## Product Change Notification—PCN# PCN001070

We would like to inform you that Moxa is going to make changes to the SDS-3008 and SDS-3016 Series. These changes will be implemented December 01, 2024. Please review the details below to determine how these changes will affect your products and/or operations.

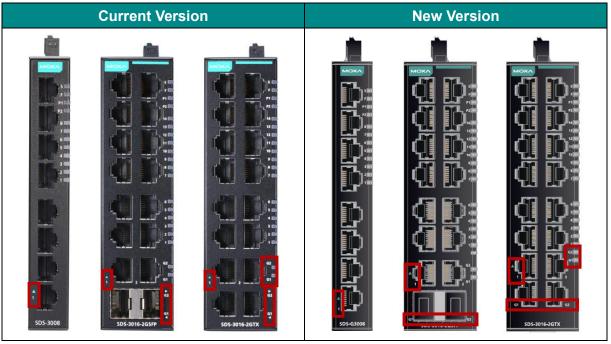
The inscription with the port number shifts slightly.
